Defense Distribution Depot San Joaquin California  
Tracy Site, Tracy, California

# Explanation of Significant Differences to the Selected Remedies in the ROD for SWMUs 2, 3, 7, and 33, Building 30 Drum Storage Area, and the Northern Depot Soils Area

FINAL

July 2001

**Figure 2-3.**  
**Location of Pump Station – SWMU 4**  
**Defense Distribution Depot San Joaquin - Tracy**

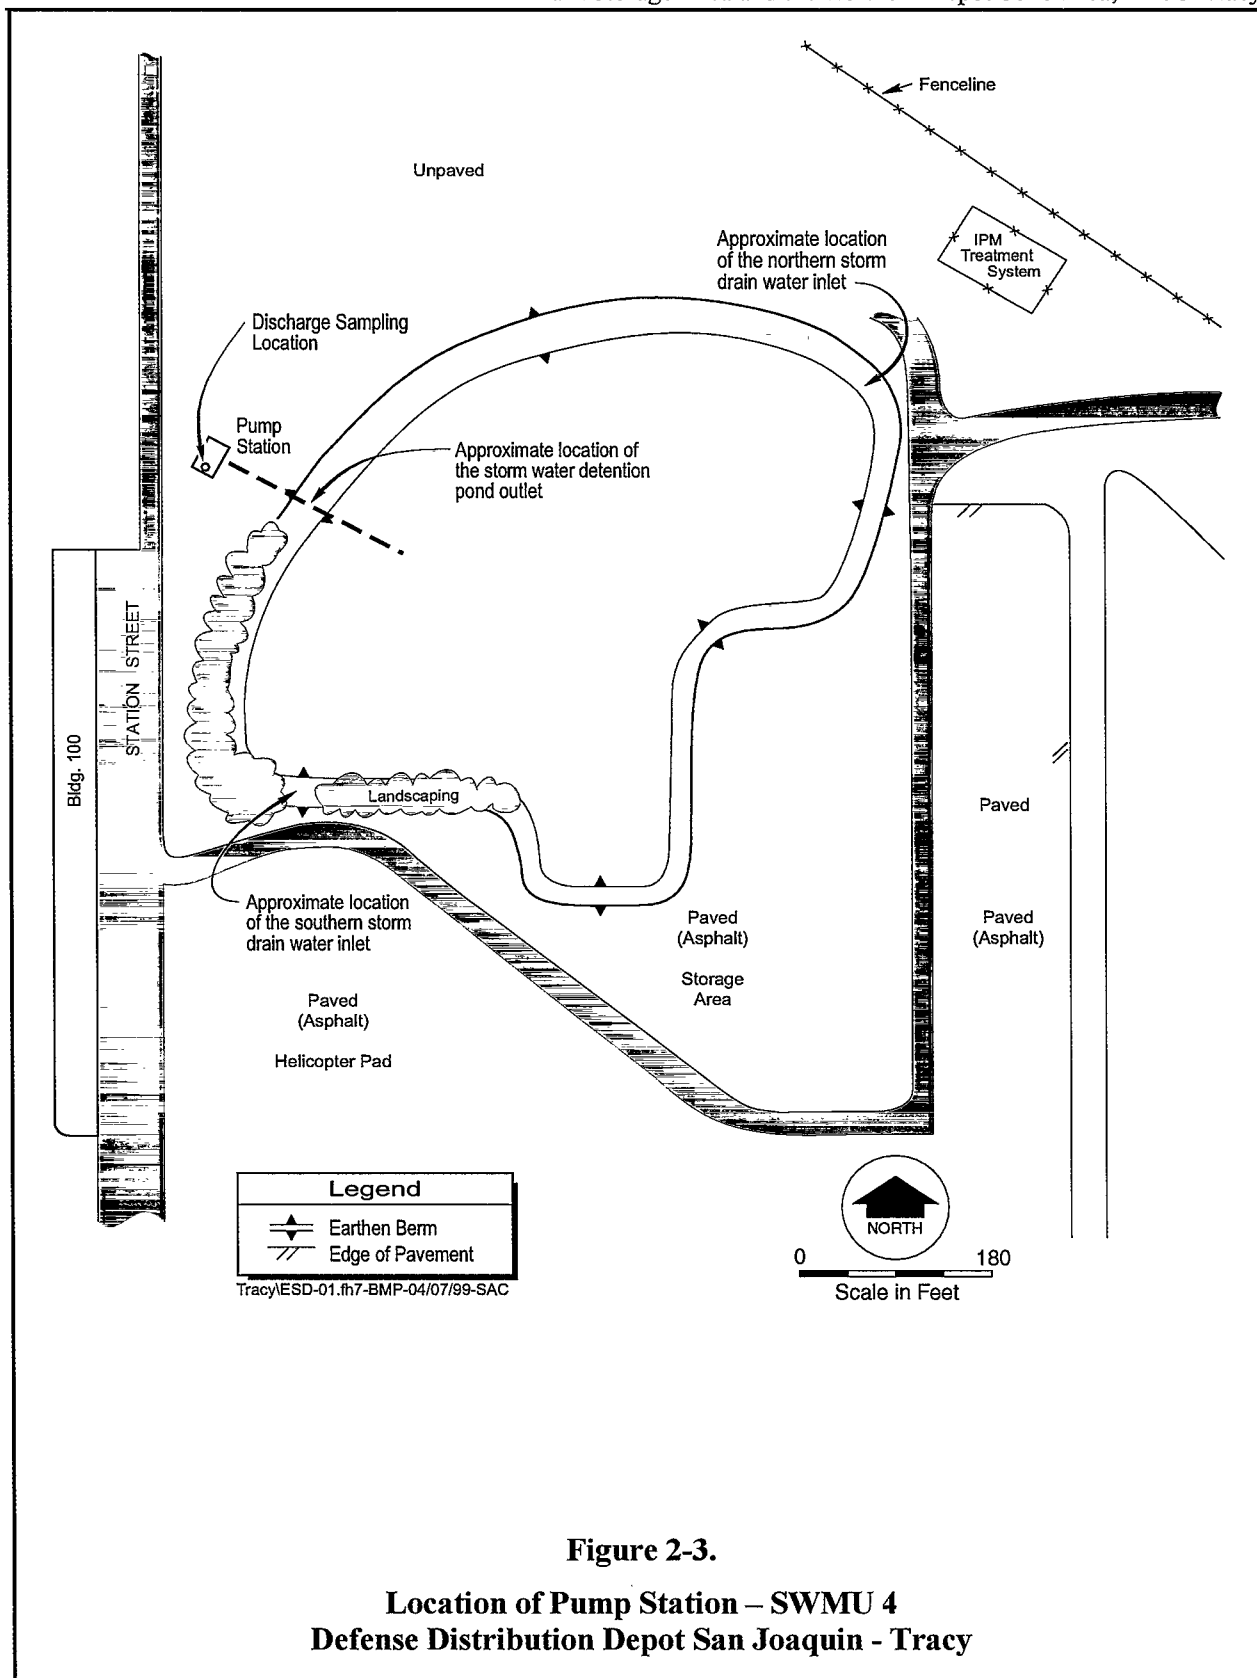
**2.5.4** Changes include deleting excavation and disposal of sediment from the Storm Water Detention Pond. The revised selected remedy still requires the construction of an overflow weir to prevent sediment from being discharged in the storm water. The immediate construction of a sediment trap will be deferred pending an evaluation of the ability of the weir to retain sediment.

**2.5.5** As part of the selected remedy, an evaluation of the impact of sediment on water quality will be performed. After construction of the weir in the Storm Water Detention Pond, discharges from the pond will be monitored to document compliance with fresh water chronic AWQCs (Radian, 1999b). Samples for monitoring compliance with the AWQCs will be collected from the discharge chamber of the pump station that discharges water from the Storm Water Detention Pond into the irrigation district channel. The location of the pump station is shown on Figure 2-3.

Remedy Component	Revised Remedy
Excavation of sediment	Unnecessary <sup>a</sup>
Disposal of sediment	Unnecessary
Construction of overflow weir	Unchanged
Construction of sediment trap	Pending evaluation of ability of overflow weir to retain sediment <sup>a</sup>
Evaluation of sediment impacts to ambient water quality criteria	Unchanged <sup>a</sup>
Groundwater monitoring	Unchanged

**Figure 4-1.**  
**Soil Contamination in Northern Depot Area and Previous Sampling Locations**  
**Defense Distribution Depot San Joaquin, Tracy Site**

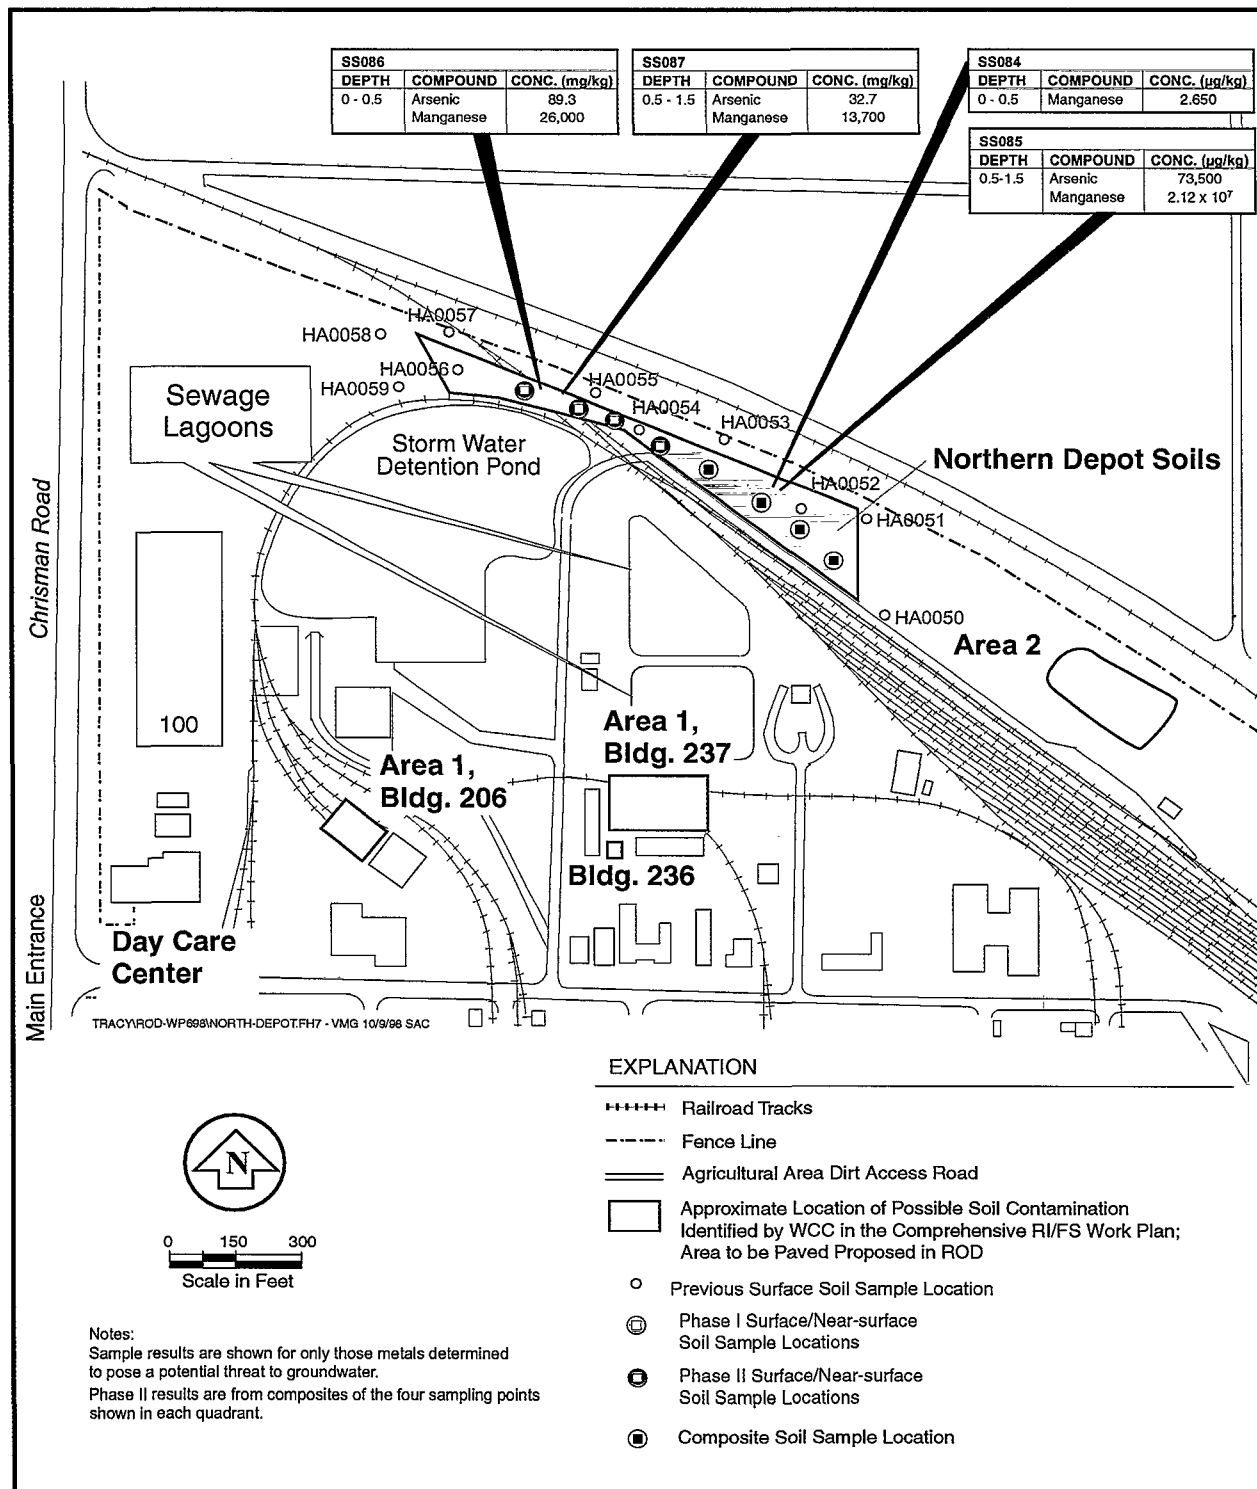
**4.3.2** The soil in the Northern Depot Area at DDJC-Tracy requires remediation to address unacceptable risks to human health. However, the units for the arsenic and manganese concentrations in Table 8-14 of the RI/FS (Montgomery Watson, 1996b) and in the table following paragraph 9.7.9.3 of the ROD (Radian, 1998a) were incorrect. This conclusion was confirmed by reviewing Table C-65 in *Comprehensive Site-Wide Baseline Risk Assessment* (Montgomery Watson, 1996a). Table C-65 provides the data that were used as a basis for calculating background levels and cleanup standards. The exposure point concentrations in Table C-65 are in mg/kg, not  $\mu\text{g/kg}$ . Cleanup standards are obtained by dividing the exposure point concentration by the total hazard quotient.

Analyte	Revised Cleanup Standard (mg/kg)
Arsenic	48
Manganese	812

**Figure 6-1**  
**Institutional Controls for**  
**SWMU 7- (South Area) - Burn Pit No. 1**  
**Defense Distribution Depot San Joaquin - Tracy**

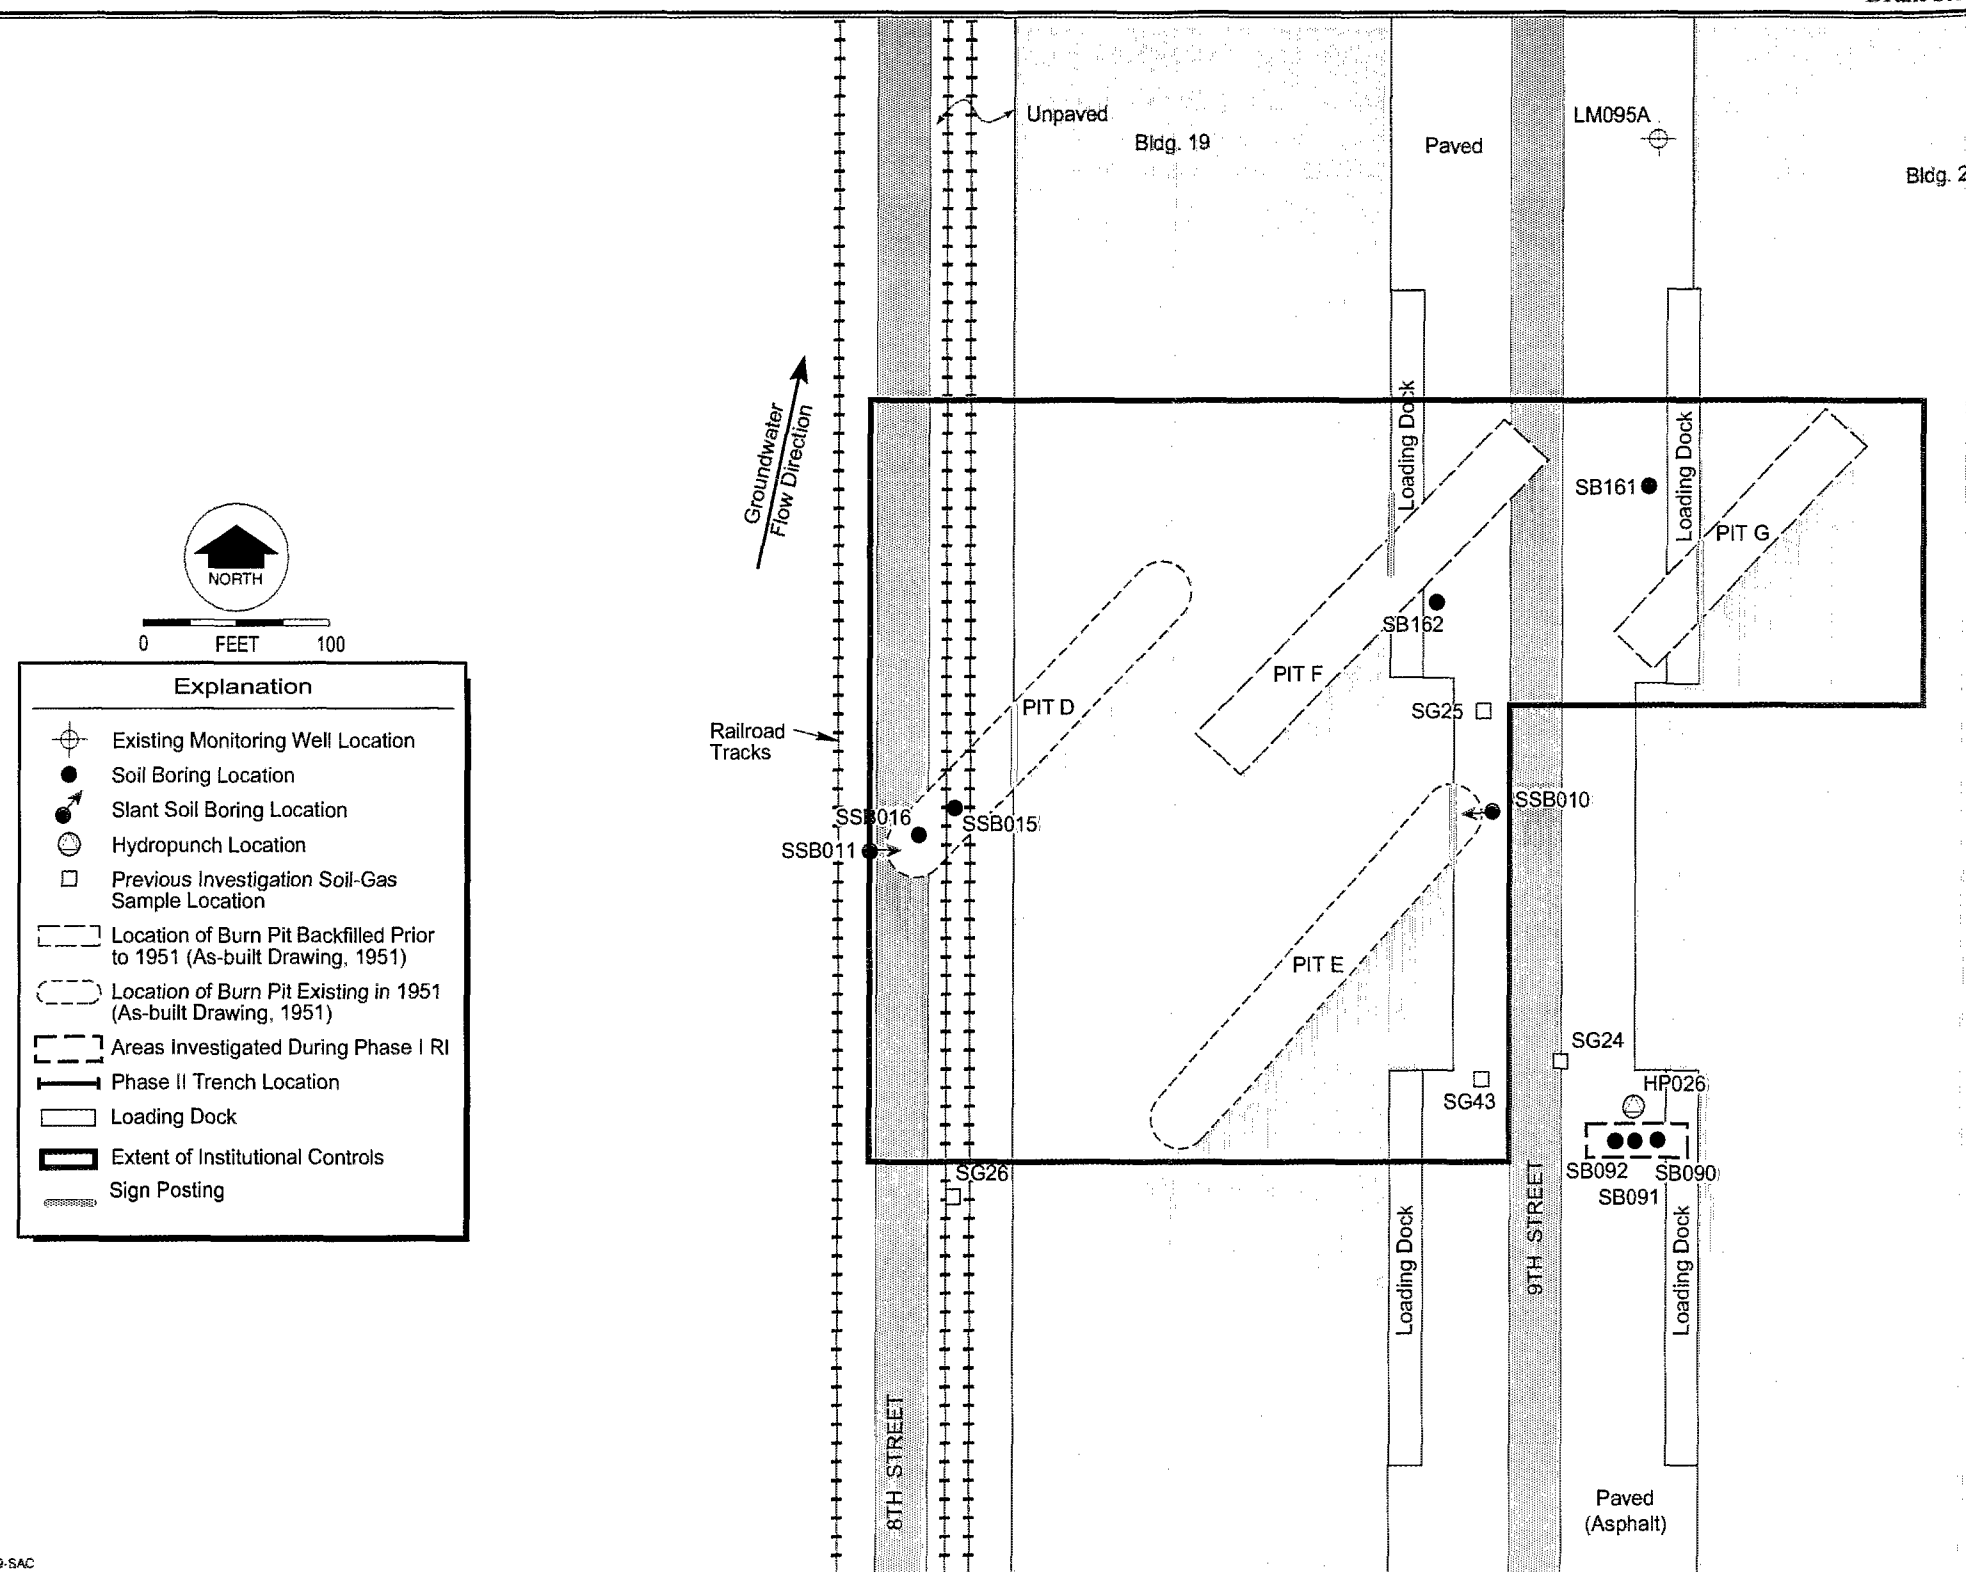
SWMU 7 be maintained. Removal and/or modification of the pavement or building slabs constitutes disruption of the selected remedy and triggers notification of the agencies and follow-up activities to ensure that the controls are fully restored. Maintaining the existing structures and pavement prevents the infiltration of surface runoff that could otherwise transport contaminants to groundwater.
